City of Ramsey
Agenda
Special Planning Commission
Monday, June 12, 2017
7:30 pm
Council Chambers, 7550 Sunwood Drive NW

Review Sketch Plan for Cole Addition Sketch Plan (Project No. 17-132); Case of Bryon and Lynn Cole

DATE	6/9/17	PROJECT ADDRESS	10-32-25-31-0002, 10-32-25-32-0006, 10-32-25-32-0005
PROJECT. TITLE	COLE ADDITION, SKETCH PLAN REVIEW		
ESCROW #			
DEPARTMENT:	Community Development: Planning Division (Zoning Code)		
TECHNICAL REVIEWER:	Name: Alec Henderson, Planning Intern Phone: (763) 576-4314 Email: AHenderson@ci.ramsey.mn.us

We offer the following comments regarding the Sketch Plan submittal for Cole Addition as it relates to the City's Zoning Code. The Sketch plan submittal consists of seven (7) sheets, prepared by LANDFORM dated May 23, 2017.

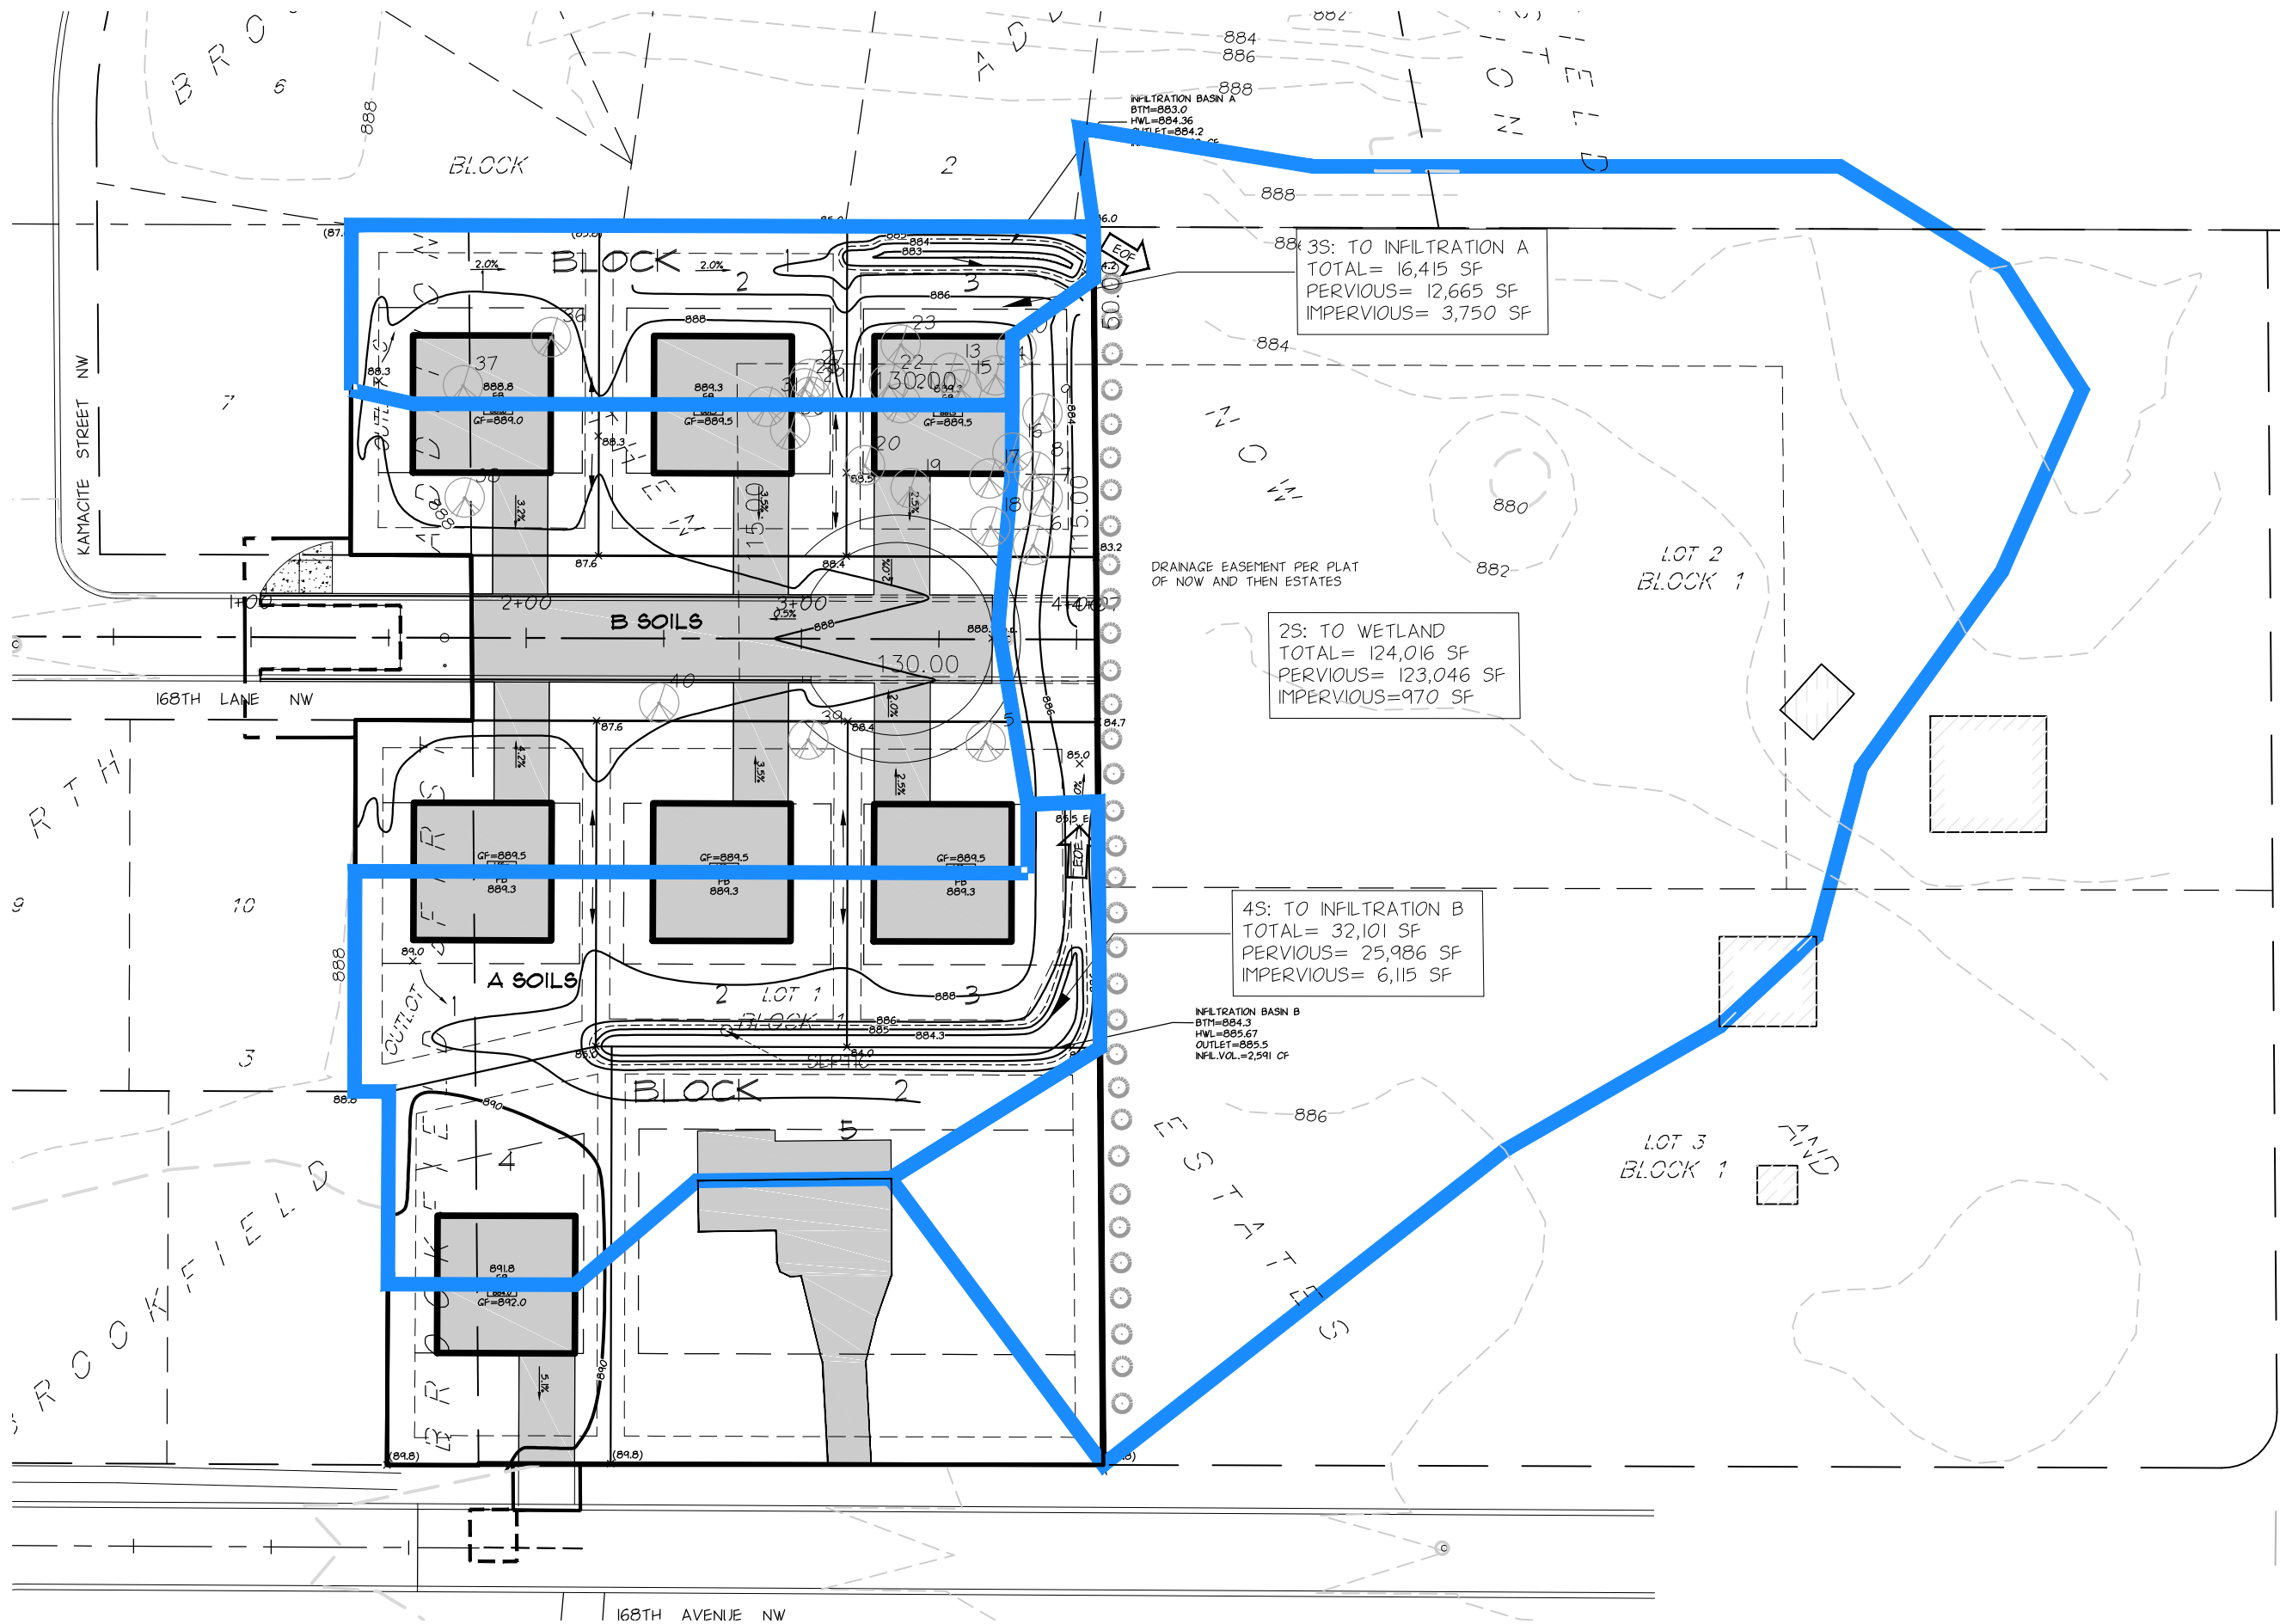
Grading and Drainage Plans: A permit from the LRRWMO will be required. There is a significant drainage easement over a portion of the Property that is proposed to be vacated. While a memorandum has been prepared outlining how this drainage will be accounted for, Staff has not had sufficient time to review that data in great detail. Addressing this drainage issue will need to be resolved for this project to move forward.

Street Widths and Design

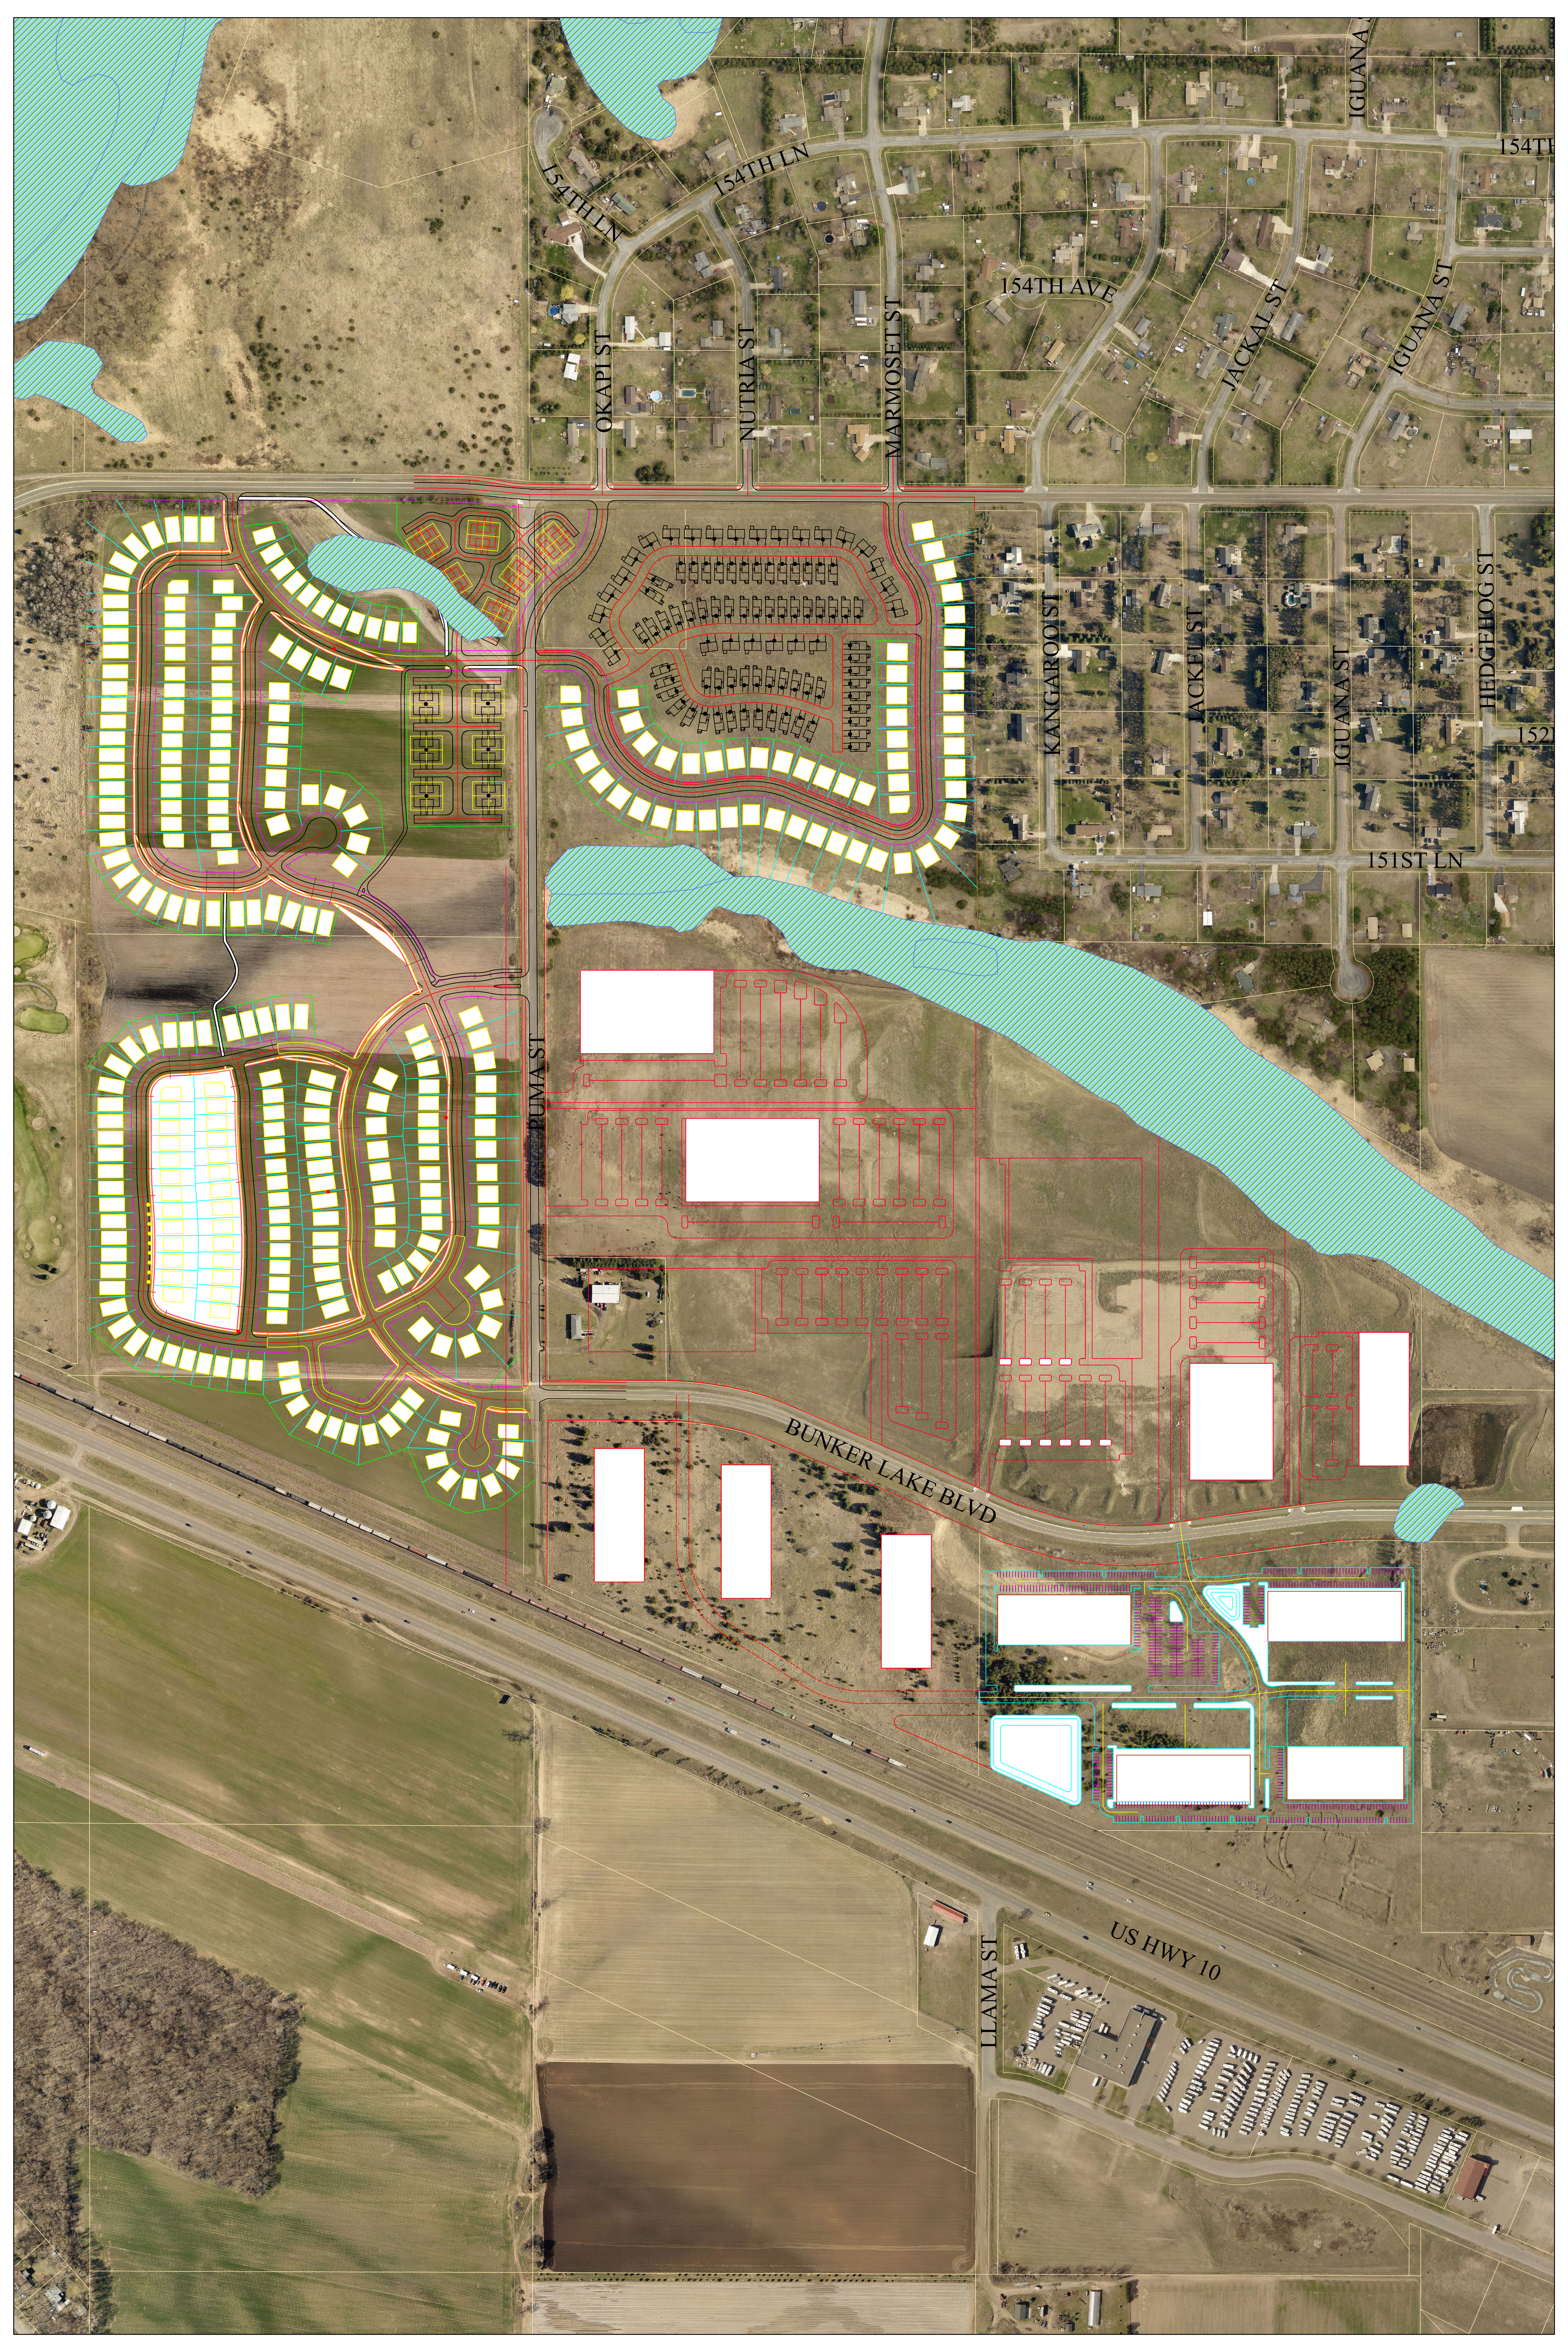
The sketch plan proposes both public and private streets within the development. The public streets are shown to have a right-of-way width of 60 feet (actual road width unknown) and the private streets are shown at a total width of 28 feet. The proposed street widths for private roads meet the requirements of the R-2 zoning district with parking permitted on one side of the street. It is unclear if the public roads meet city standards as the road widths were not explicitly identified.
